**TSG-RAN Meeting #9
Hawaii, US, 20 - 22 September 2000**

TSGRP#9(00)0384

Title: Agreed CRs to TS 25.427

Source: TSG-RAN WG3

Figure 11: Uplink data frame structure

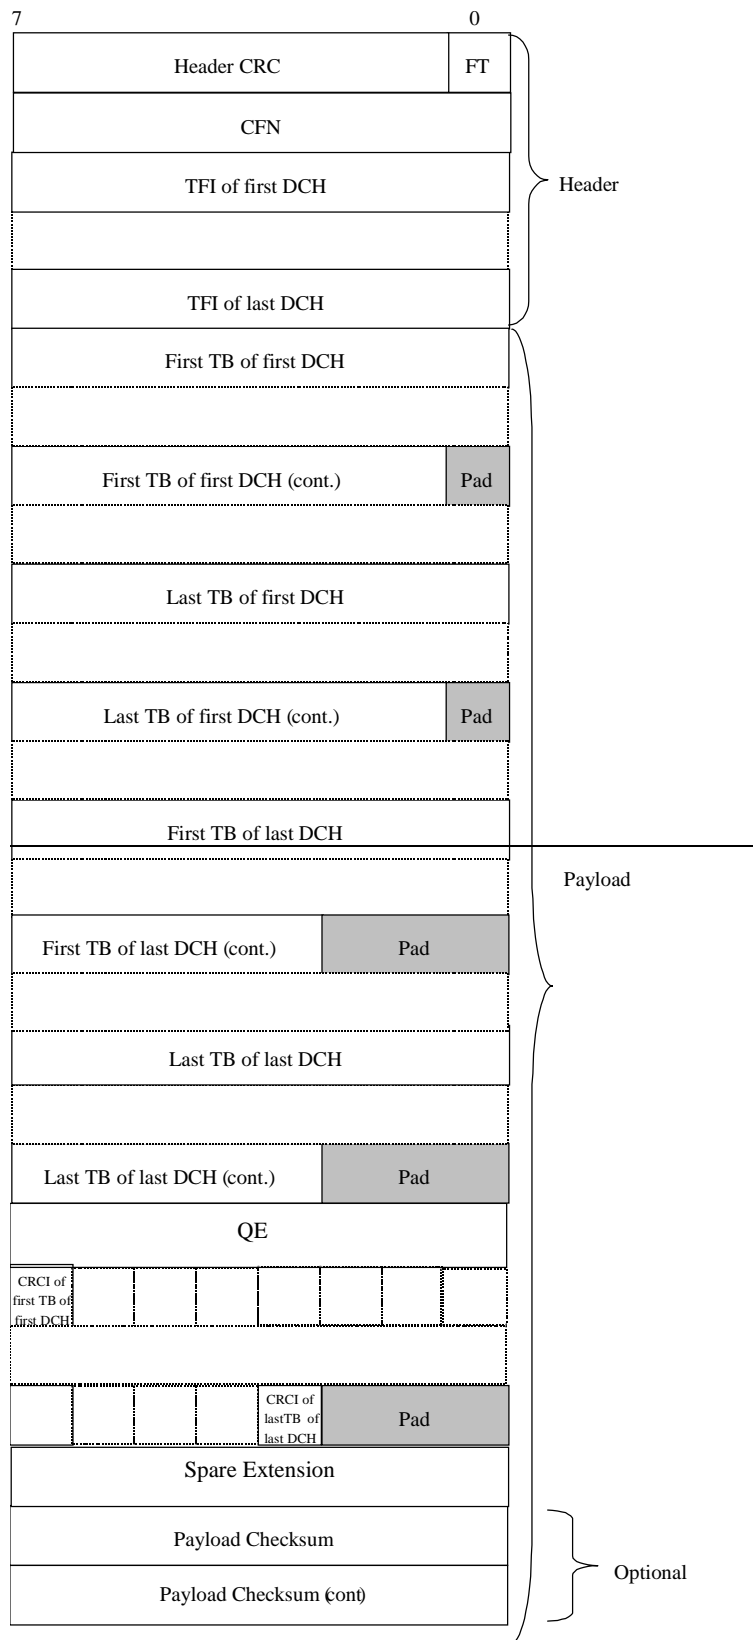
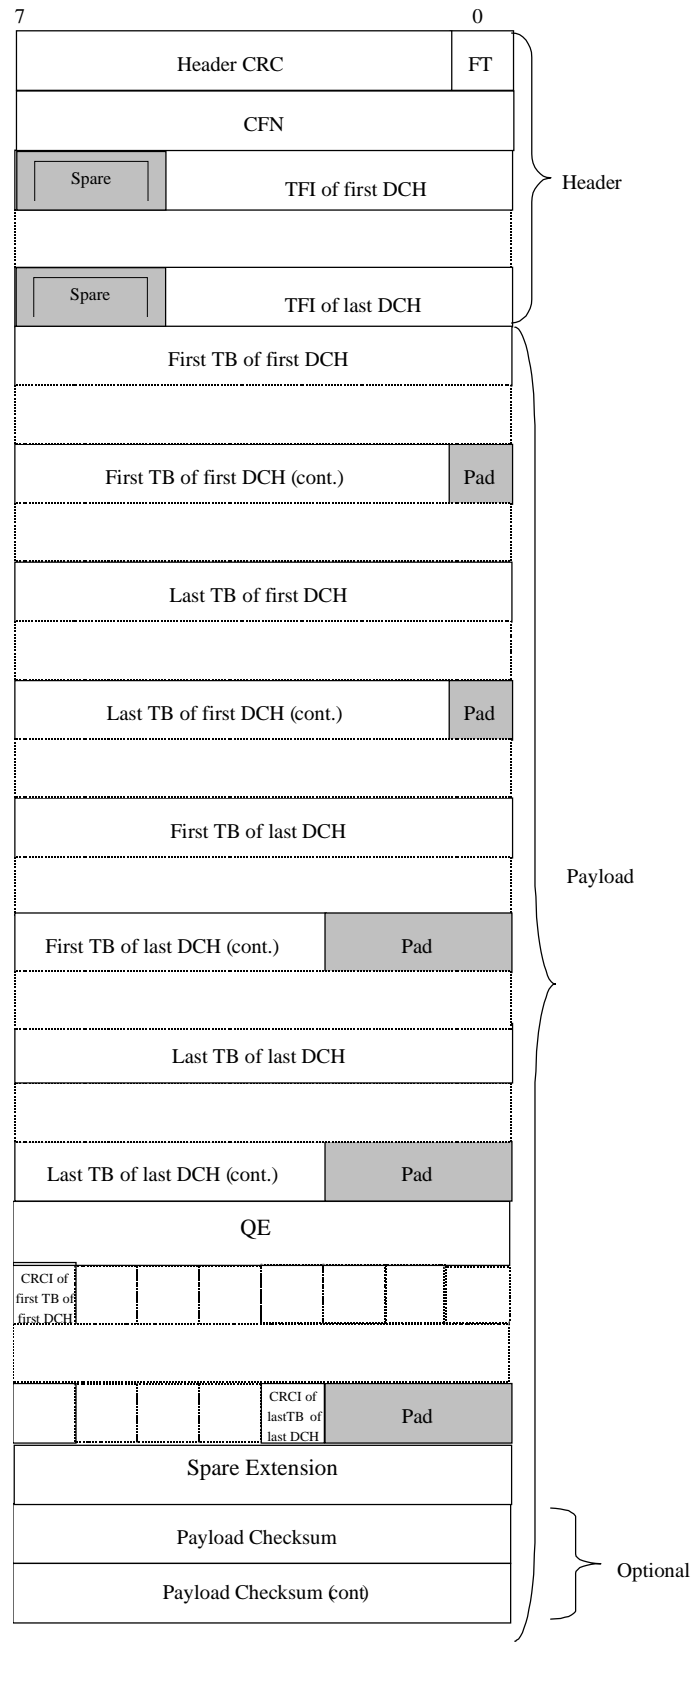
Reason for change: The maximum number of TFIs has been restricted to 32. TFI IE occupies one octet, although TFI could be identified with 5 bits or in many cases with less than 5 bits. This CR proposes that the three most significant bits are set to spare.

Value range: {0-~~255~~31}.

Field length: ~~8~~5 bits.

Figure 21: [FDD - Structure of the payload for the DSCH DL signalling control frame

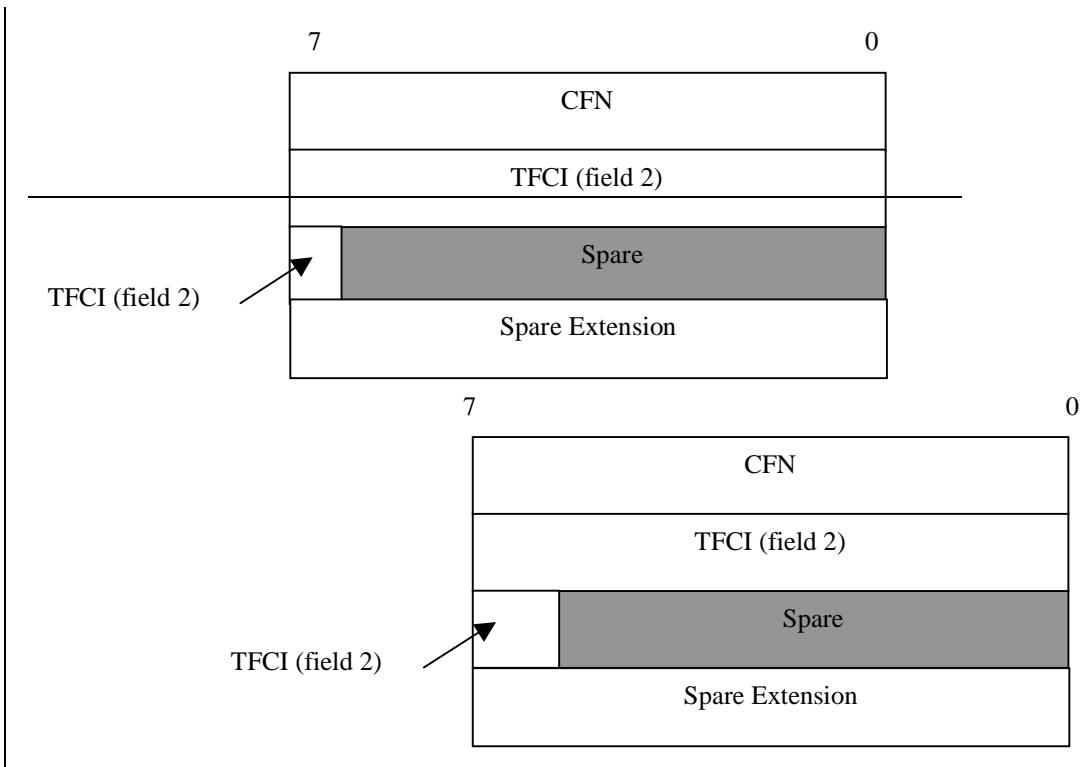
Reason for change: Align the length of TFCI field 2 in 6.3.3.8.2 with the definition in RRC.

Value range: {0 - 1023544}

Field length: 9-10 bits

Figure 1: Uplink data transfer

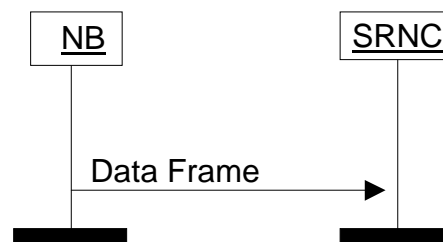
The calculation of a Bit Error Rate during DTX applied on uplink DCHs in TDD had been an open issue. This CR describes how Node B shall behave in this case.

For any TTI in which the Node B Layer 1 generated at least one CPHY-Out-of-Sync-IND primitive, the Node B is not required to send an UL data frame to the SRNC.

When UL synchronisation is lost or not yet achieved on the Uu, UL data frames are not sent to the SRNC.

When Node B receives an invalid TFCI no data frame shall be sent to the SRNC.

Figure x: Structure of the Timing Advance control frame

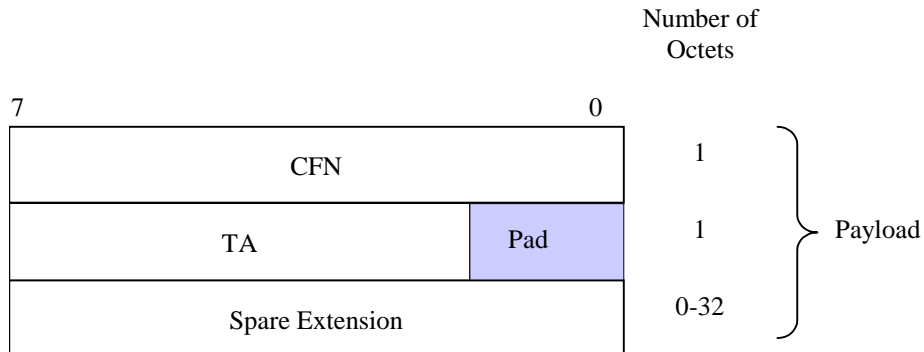
This procedure is used in order to signal to the node B the adjustment to be performed by the UE in the uplink timing.

The CFN value in the control frame is the frame that the timing advance will occur and is coded as in subclause 6.2.4.3.

Description: UE applied UL timing advance adjustment.

Value range: : 0-252 chips, and the resolution is 4 chips.

Field length: 6 bits.

Figure 11: Uplink data frame structure

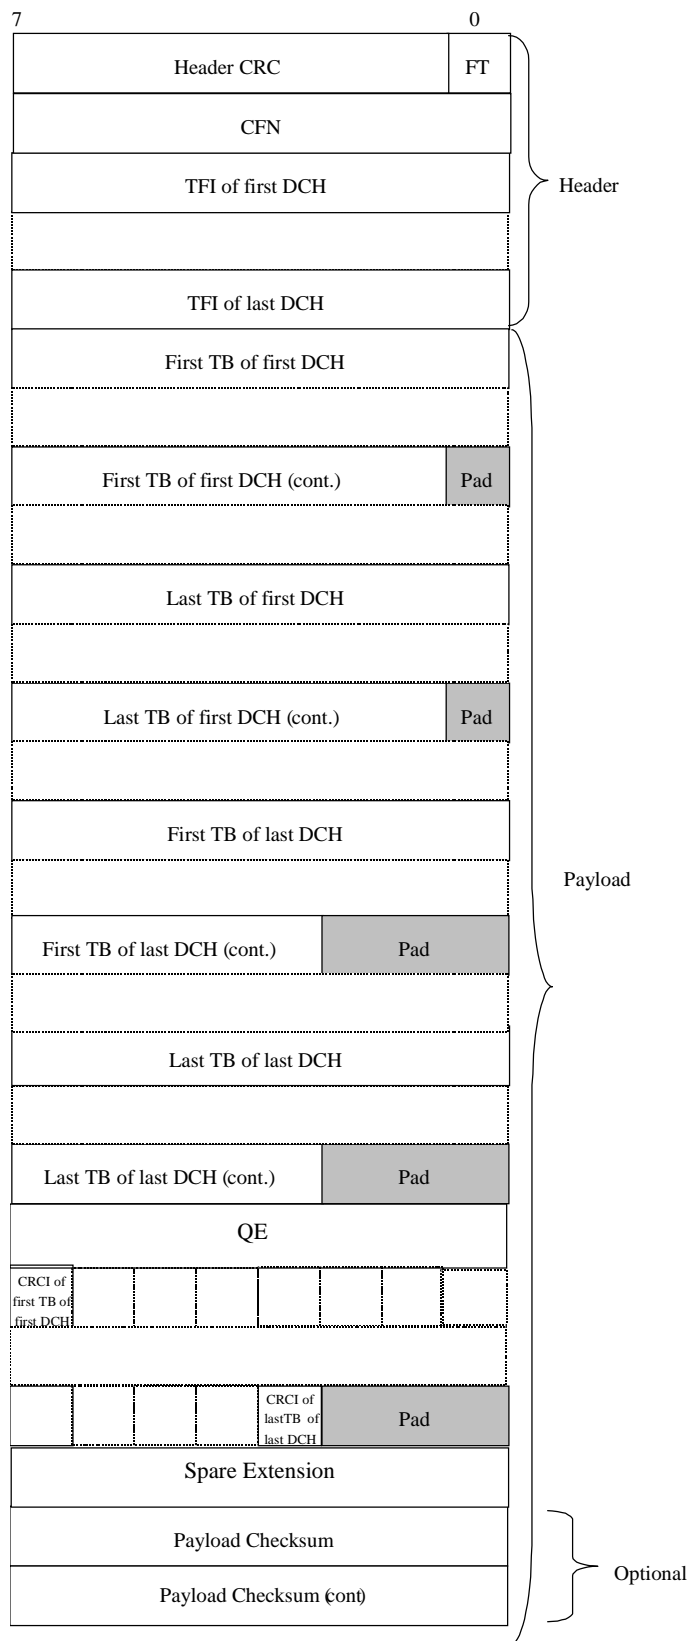
There is a CRCI for each TB included in the frame. If the CRC indicators of one data frame do not fill an integer number of bytes, then bit padding is used as shown in the figure in order to have the octet aligned structure (ex. 3 CRCI bits require 5 bits of padding, but there are no CRCI bits and no padding, when number TBs is zero).
